Welch Allyn, Inc. 4341 State Street Road Skaneateles Falls, NY 13153 USA	URGENT: Field Safety Notice	2021-07-001-MKE-005
-----------------------------------------------------------------------------------	------------------------------------	---------------------

ELI280, MLBUR280 and BUR280 Electrocardiographs

ELI280 resting electrocardiograph - Patient mismatch/Software Upgrade

FSCA-identifier: 2021-07-001-MKE-005

Figure.1

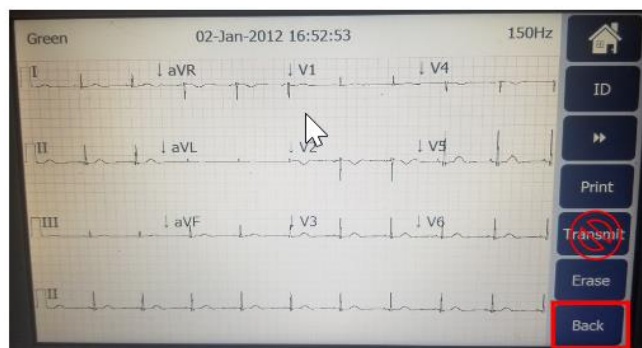
1. An ECG is acquired for Patient A and stored to the cardiograph.
2. An ECG is acquired for Patient B and stored to the cardiograph.
3. The ECG record associated with Patient A is retrieved from memory and any Patient Demographic information is edited.
4. After editing, the "Resting ECG" screen is presented as shown below. Figure 1
5. Pressing the TRANSMIT button from this screen (following any Patient Demographic edit) will transmit an ECG record other than for patient A. (see figure 2, which shows the Resting ECG screen).

If an ECG record is retrieved from the patient directory for a Patient Demographic edit to be performed, once the information has been edited and the screen above (Fig 1) is presented, do not press the transmit button. Instead, press the BACK button which will SAVE the changes to memory and present the user with the following screen, where the SYNC button can be used to transmit the desired record to the configured destination.

Figure.3

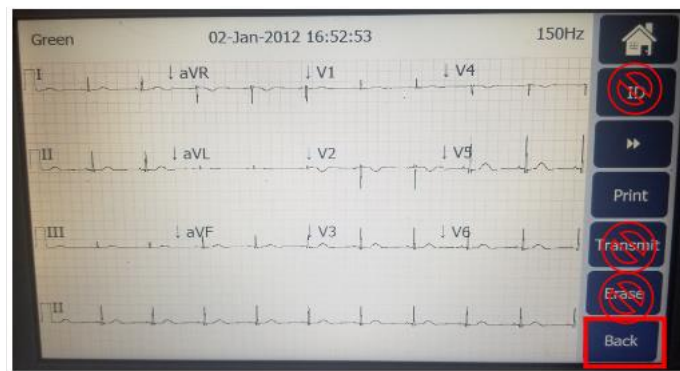
1. An ECG is acquired for Patient A and stored to the cardiograph.
2. An ECG is acquired for Patient B and stored to the cardiograph.
3. The ECG record associated with Patient A is retrieved from memory and ID information is edited.
4. After editing, the “Resting ECG” screen is presented as shown in Figure 3.
5. The user decides to make another ID Edit without leaving the “Resting ECG” screen and presses the “ID” button - Figure 3.

6. After the second edit is performed, the “Resting ECG” screen is once again presented as shown above.
7. Pressing the TRANSMIT button from this screen (following two ID edits in a row as defined above) will transmit an ECG record with the patient demographics

from Patient A and the ECG record for Patient B, this “hybrid” record is then stored in the cardiograph as second record with patient A demographics, and Patient B will no longer be listed in the directory.
